**Analysis of Impacts on Wetlands and Buffers**  
**Proposed Leidy Southeast Franklin Loop D Pipeline**  
**Monroe and Luzerne Counties, Pennsylvania**

**Prepared for:** Delaware Riverkeeper Network  
Bristol, Pennsylvania

**Prepared by:** Schmid & Company, Inc.  
Consulting Ecologists  
1201 Cedar Grove Road  
Media PA 19063-1044  
610-356-1416  
[www.schmidco.com](http://www.schmidco.com)

**June 2014**

FIGURE 8. Sample from a February 2014 FERC alignment plan.

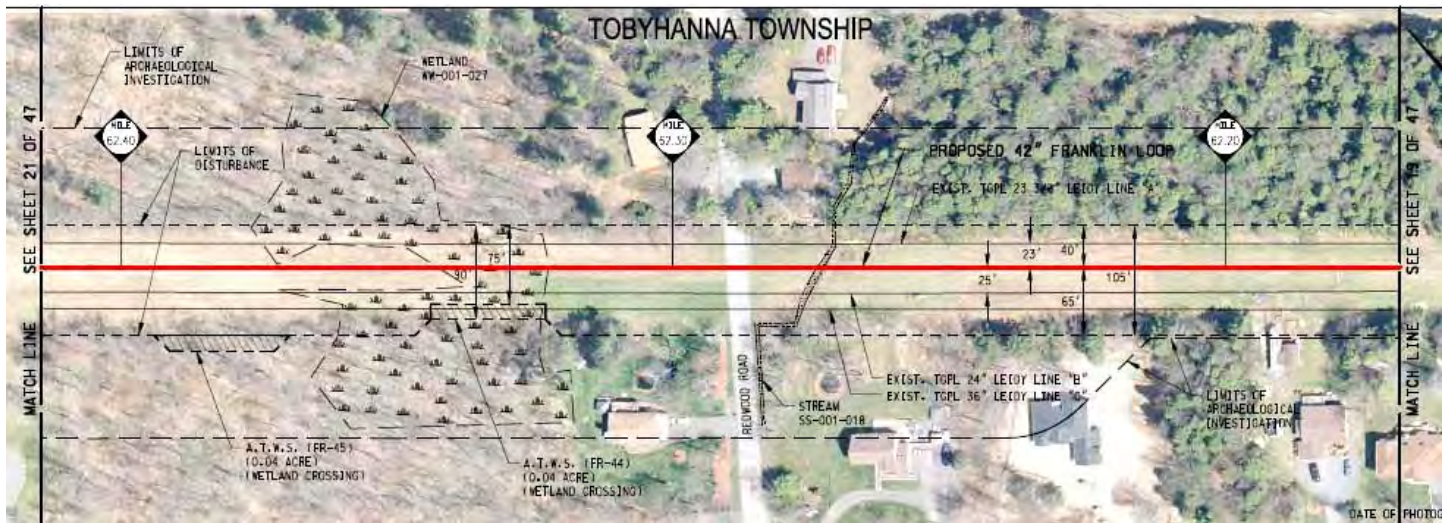
Based on remeasurement of the Applicant's February 2014 FERC alignment drawings (Figure 8), enlarged to a scale of 1:480 (1" = 40') for this assessment, the Applicant appears to propose permanent conversion from woody to herbaceous vegetation in 12 numbered wetlands totaling 6 acres (about 4.3 ac of Palustrine Forest [PFO] plus 1.7 ac of Palustrine Scrub [PSS] to become herbaceous vegetation [PEM], Table B). These totals contrast with the Applicant's statement in its 2013 Mitigation Plan (FERC Application Requirement T) that there would be only 3.84 acres of total conversion from woody to herbaceous vegetation in the Franklin Loop wetlands post-construction. For the Corps application the total forest conversion was listed as 4.07 acres. For this remeasurement the Applicant's "tree lines" on stream and wetland encroachment drawings, along with photographs and limited field inspection, were used to ascertain the extent of existing forest and scrub wetlands within proposed limits of disturbance by construction (Figures 8 and 9). The revised tallies of vegetation conversion reported here are consistent with data recorded by the Applicant's bog turtle consultant during 2013. The most detailed description of existing vegetation at each wetland in Monroe County is provided by the Applicant's bog turtle consultant, which is more accurate than that of the Applicant's summary impact tables. No bog turtle investigations were performed west of the Lehigh River in Luzerne County.

**FIGURE 10.** Excerpt from soil erosion and sediment control plan showing proposed measures for use during construction. No post-construction stormwater management plan has been submitted. Applicant's dashed 150-foot wide forest riparian buffer around disturbed stream segment is indicated by arrow.

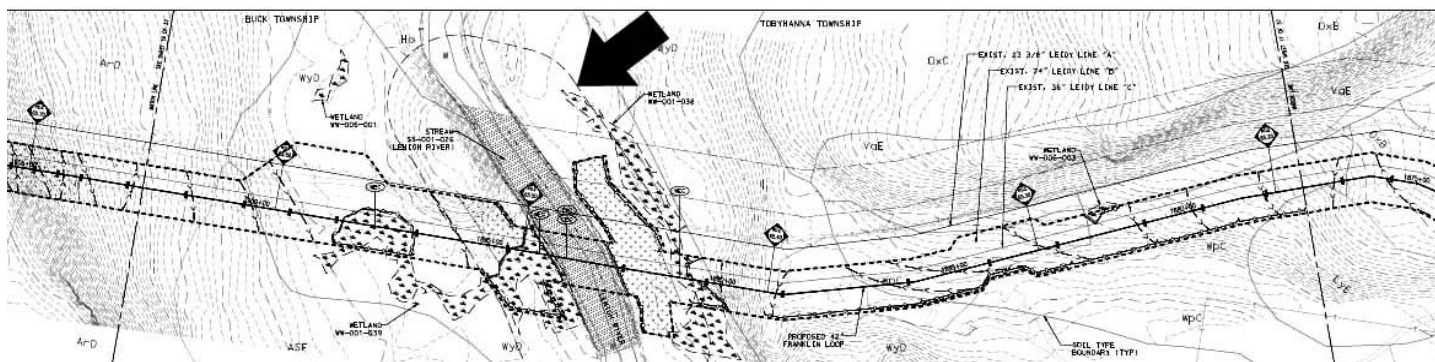
disturbed land available within the existing ROW, as for example along the east bank of the Lehigh River (northwest of Mile Post 65.40; Figure 10). Concrete coatings are not to be applied to pipes within 100 feet of streams or wetlands, and vehicle parking and refueling also are to be kept back 100 feet per FERC guidelines.

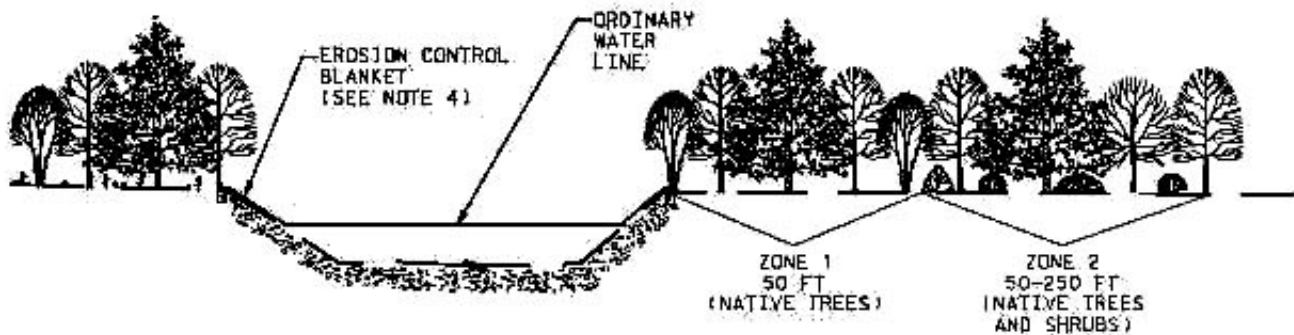
**FIGURE 11.** Detail for typical restoration of native forest riparian buffers along streams. No drawing shows where such buffers will be installed along the Franklin Loop. There are no "other waters" along the Franklin Loop. The drawings apply also to the Dorrance Loop of the Leidy Southeast pipeline.

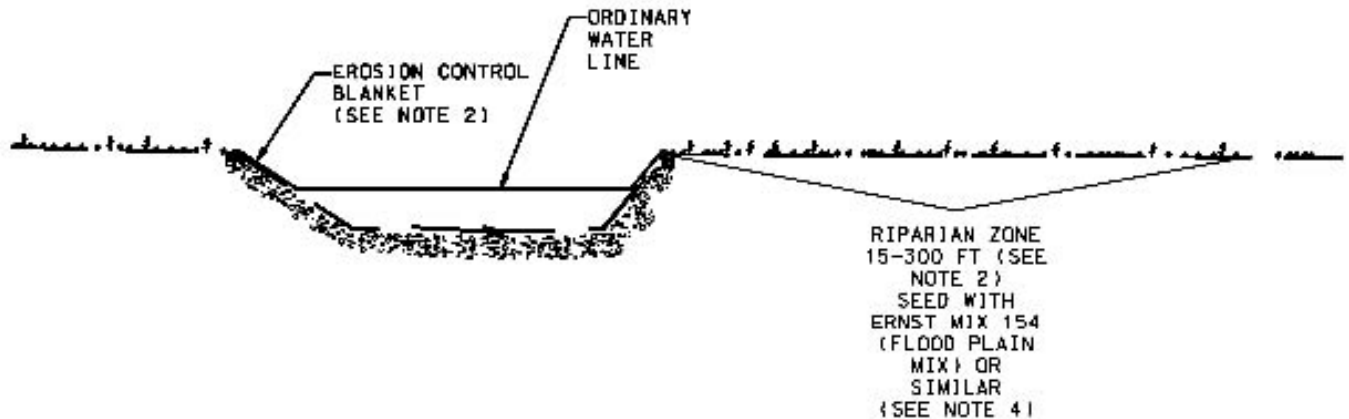
**FIGURE 12.** Detail for typical non-forest riparian buffer to be installed along the Franklin Loop. Pennsylvania regulations call for installation of forest in riparian zones wherever they currently are lacking (25 Pa. Code 102.14). The relevance of this detail to the Franklin Loop is not clear. No drawing shows where such buffers will be located

**FIGURE 16.** Compressor Station 515 at northwest end of proposed Franklin Loop. WW-006-004 and WW-013-001 are shown in the corners of the existing cleared area.

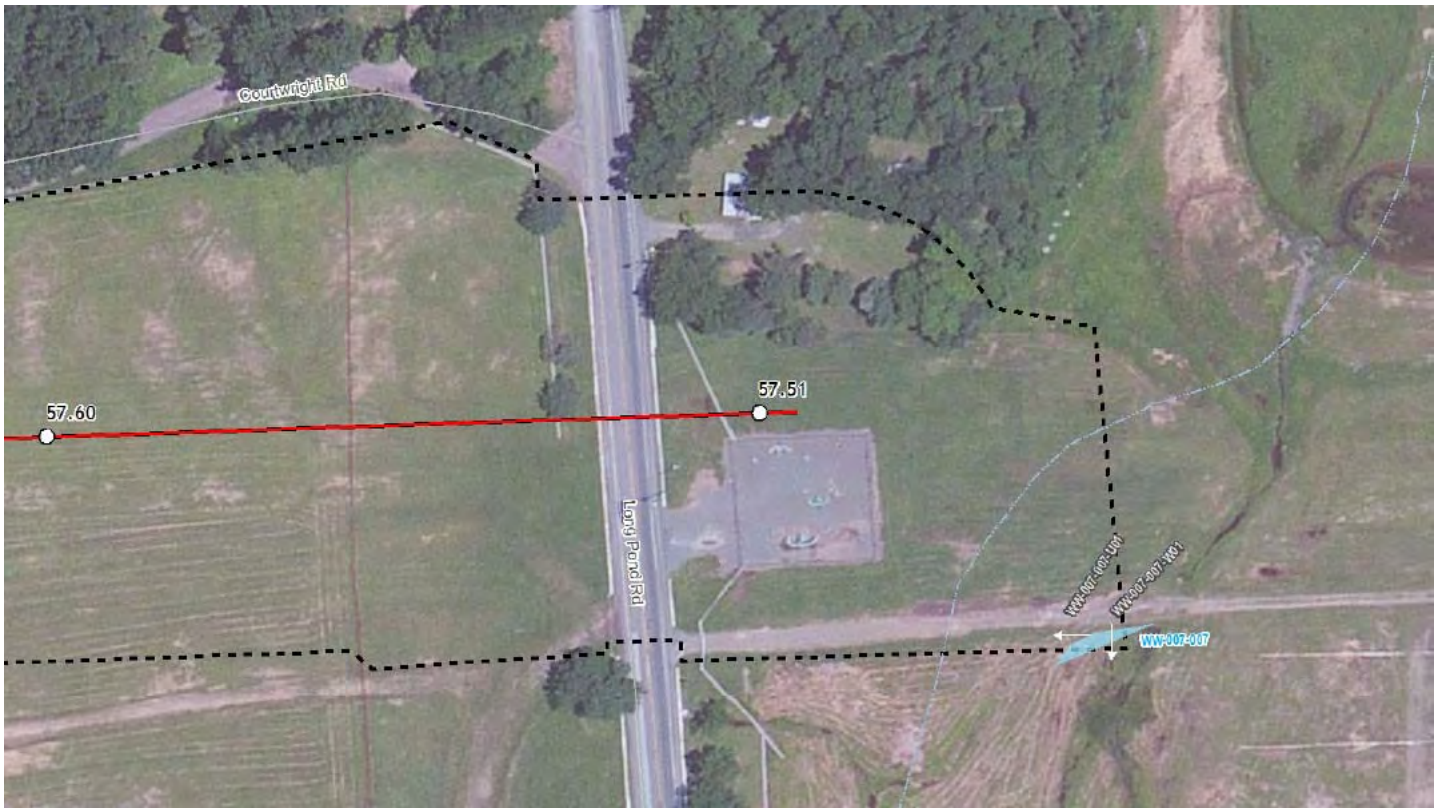
It would appear that these four wetlands could be avoided entirely, rather than converted temporarily or permanently to uplands with complete destruction of their wetland functions. The draft soil erosion control plan in fact shows sediment controls around WW-006-004, SS-009-002, and SS-009-001, as if these features were to remain undisturbed. It is difficult to envision successful restoration of functions in these wetlands following pipeline construction. Three would be isolated from natural vegetation and other wetlands. Instead, three of them probably could be surrounded by a 50-foot wide setback against new construction activities as advocated in the FERC guidelines, with no significant impediment to the proposed construction. (At WW-007-006 the adjacent land already is being used for pipe laydown and for roadways at the Applicant's Mount Effort Pipe Storage Yard, Figure 17, but most of this wetland is outside the proposed limit of new disturbance.) Wetland WW-007-007 is adjacent to an unrecognized streamcourse (Figure 18).

**FIGURE 37.** Applicant’s proposed wetland mitigation plan, Bleiler Farm, Lehigh County, Pennsylvania. Ross Valley Road is at left; Bausch Road parallels Switzer Creek in the center of the view in the upper section of the drawing. Homestead Road is at the center bottom.

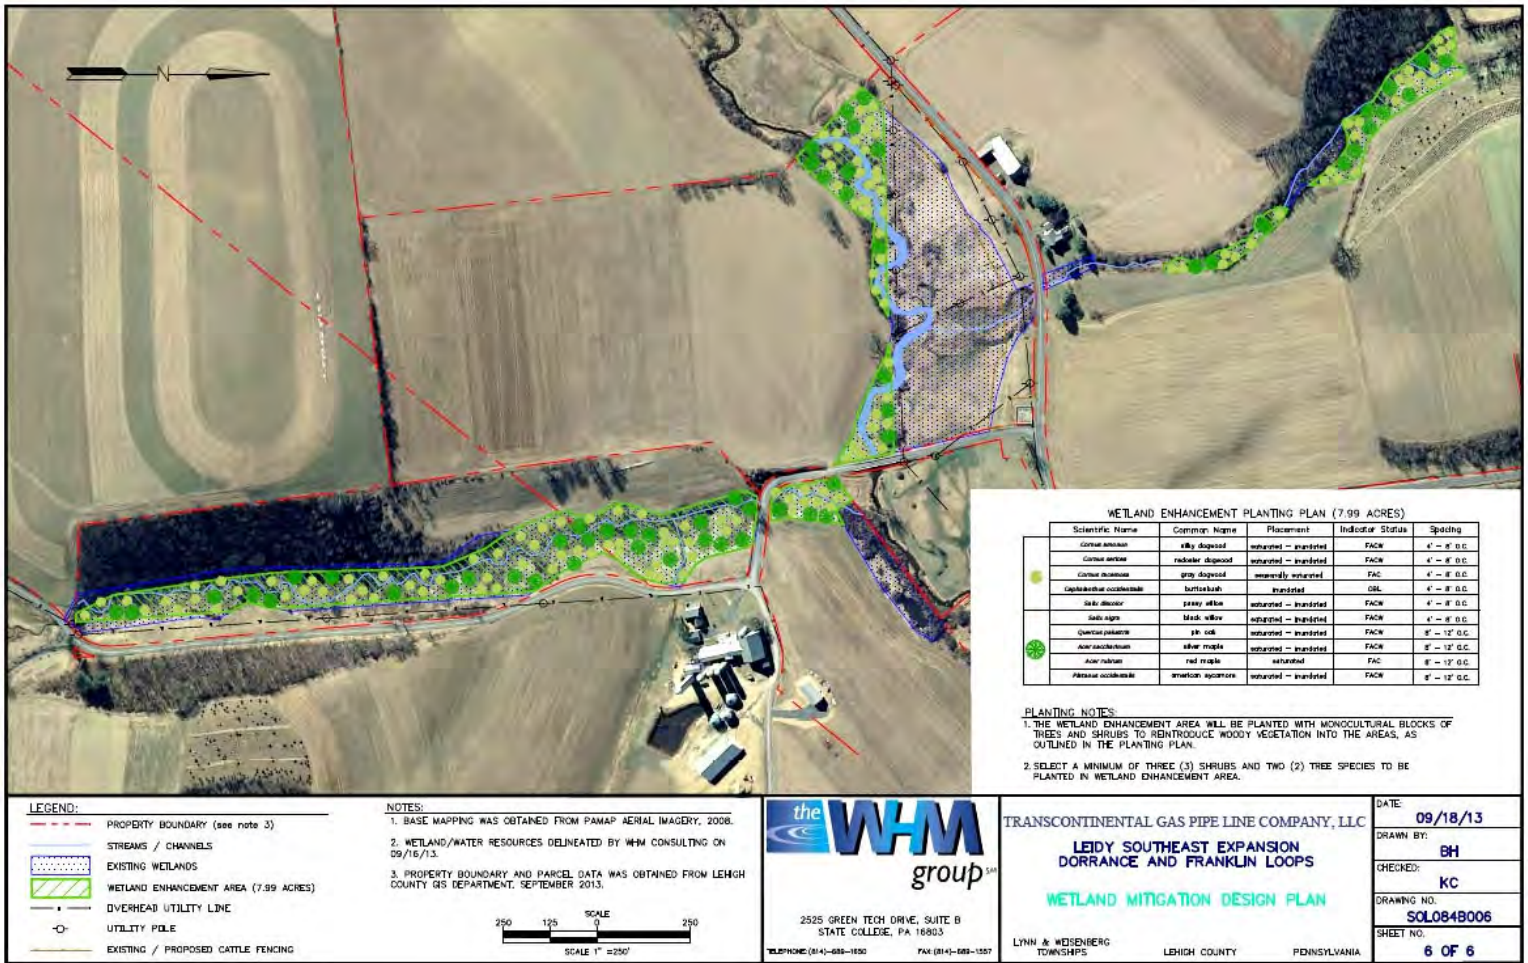
The Applicant does not identify any specific wetland functions that will be enhanced at the mitigation site or compare them with functions lost along the Franklin Loop. About 4,350 linear feet of Lehigh County streambanks appear to be slated for "improvement" by planting the 56 trees and 104 shrubs in existing wetlands, counting each side of the streams separately. The breakdown is 375' along one side of a Switzer Creek segment in Wetland 1; 1,050' along both sides of a segment of UNT 03529 (Applicant's UNT #1) in Wetlands 2 and 3 north of Switzer Run; and 2,100' of UNT 03530 (Applicant's UNT #1) south of Switzer Run (Figures 37 and 39). No plantings are proposed by the Applicant in

most of Wetland 1 or in Wetland 5 at the Bleiler Farm. At the PADEP-recommended riparian forest planting rate of one tree or shrub per 100 square feet, the Applicant's proposed planting of 160 individual trees and shrubs would revegetate about 0.4 acre of streambank buffer (107 linear feet or 54 feet if along both sides of the stream).
